NRC DOCKET NUMBERS 50-424 AND 50-425
CONSTRUCTION PERMIT NUMBERS CPPR-108 AND CPPR-109
VOGTLE ELECTRIC GENERATING PLANT - UNITS 1 AND 2
COMMENTS ON DRAFT ENVIRONMENTAL IMPACT STATEMENT

Comments on Draft Environmental Impact Statement related to
the operation of Vogtle Electric Generating Plant, Units 1 & 2

FIGURE 2.1-11

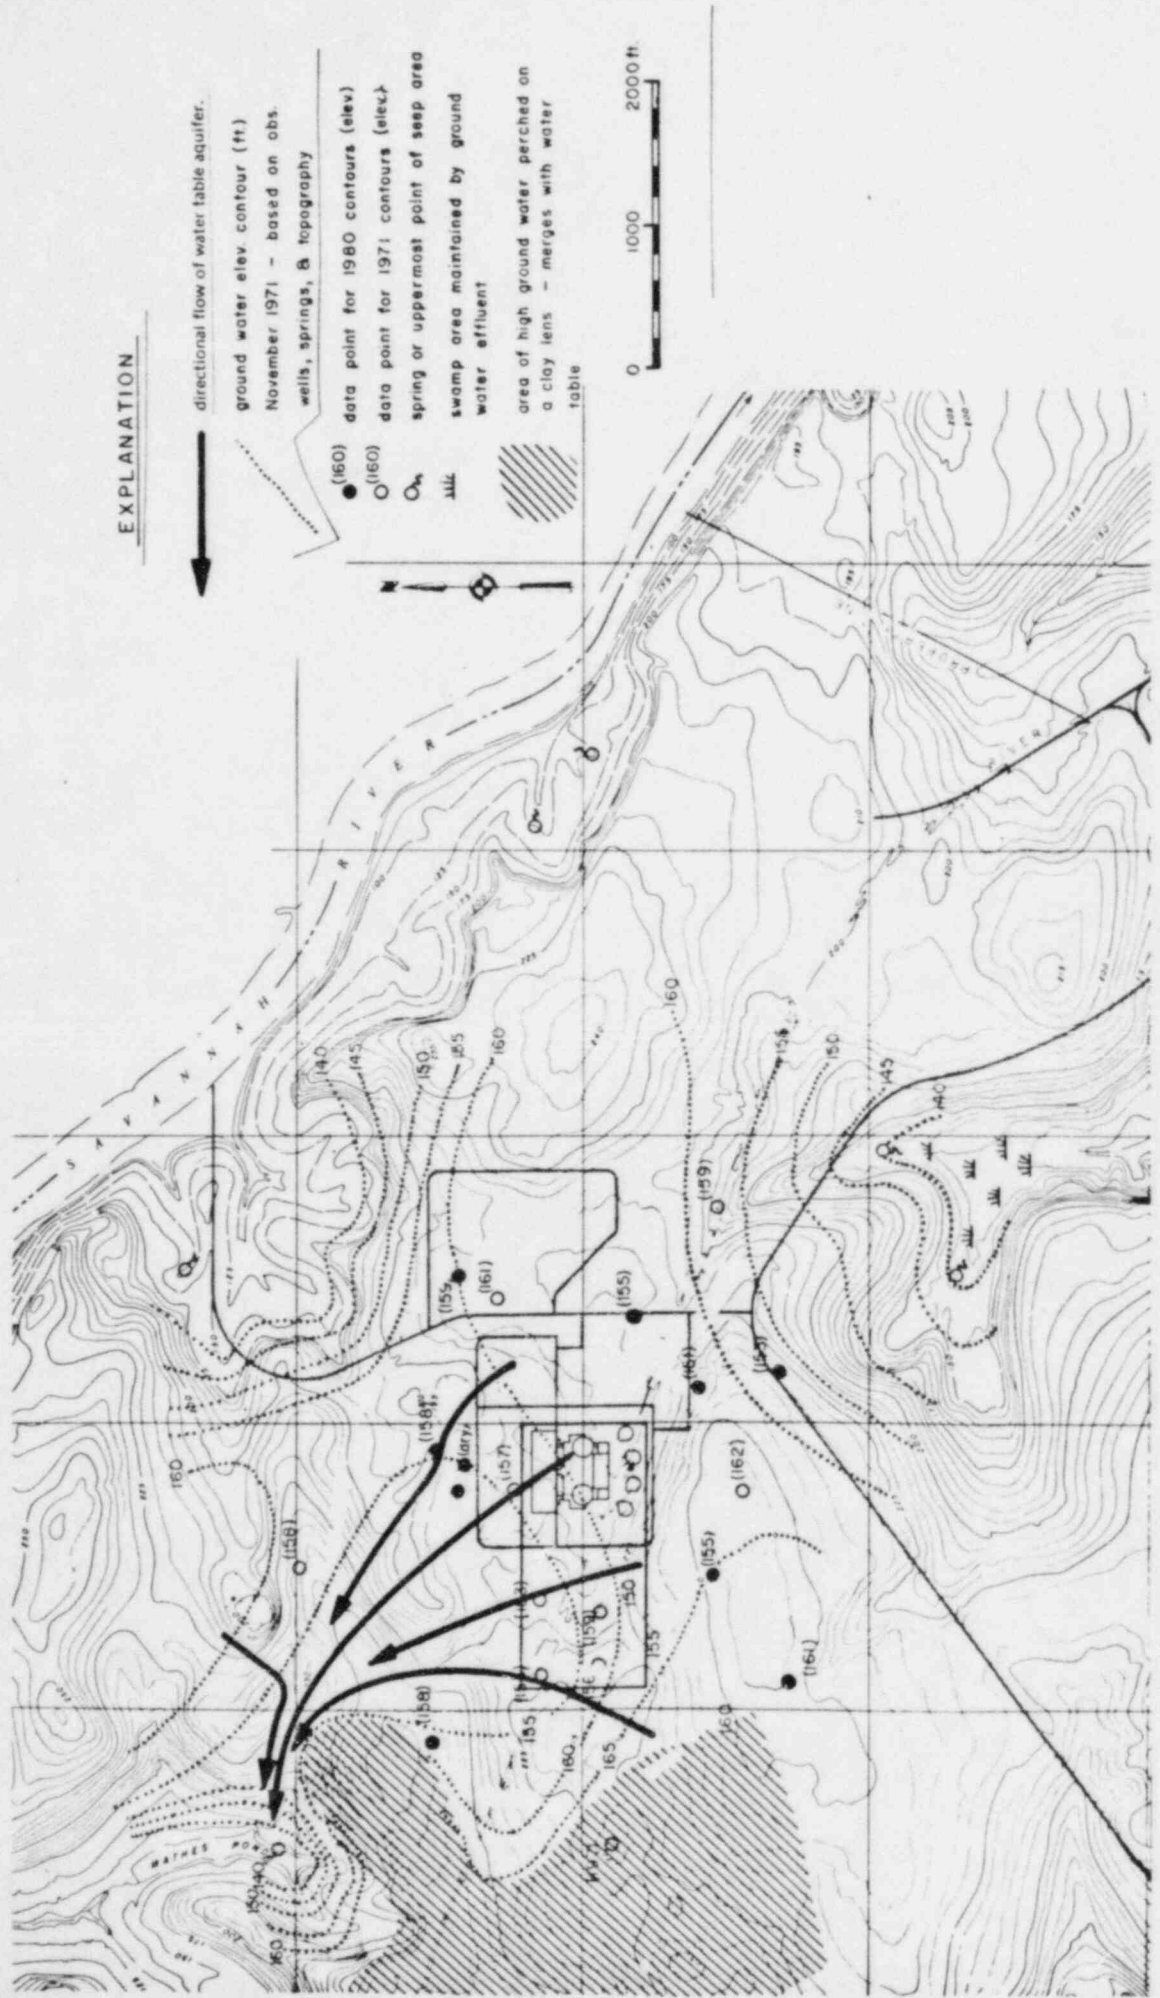
Note: The OL-ER Figure 2.1-10 from which DES Figure 4.11 was reproduced has been updated and is included as Attachment 1 to these comments. Attachment 2 is a figure showing the flowpath of the water table aquifer at the Vogtle site. These figures will be added to the next ER-OL amendment.

b. 10,000 gal/min dilution supplied by Figure 4.3 Plant water use

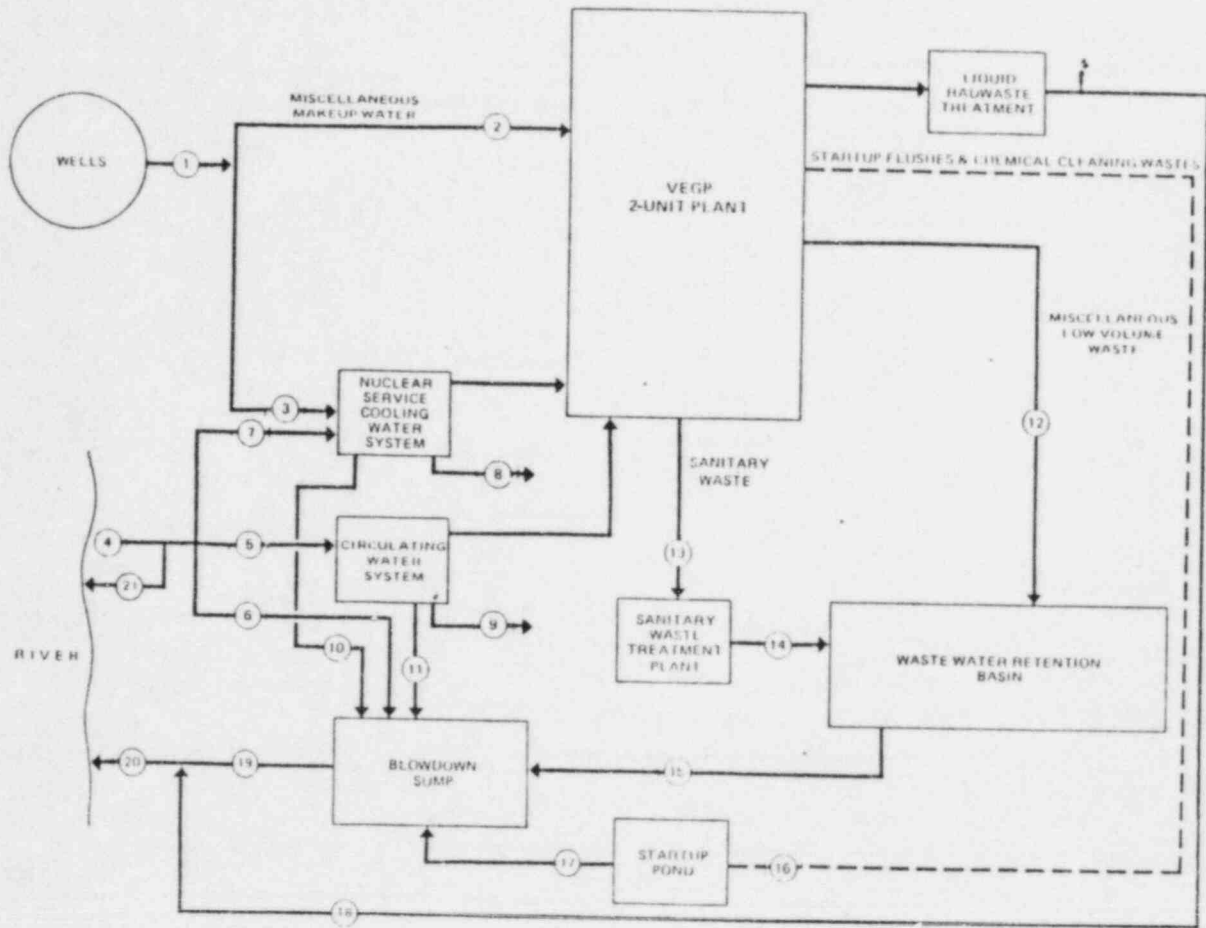
See Attachments 3 through 6 for corrections to Figure 4.3 and Tables 4.1, 4.2, and 4.5.
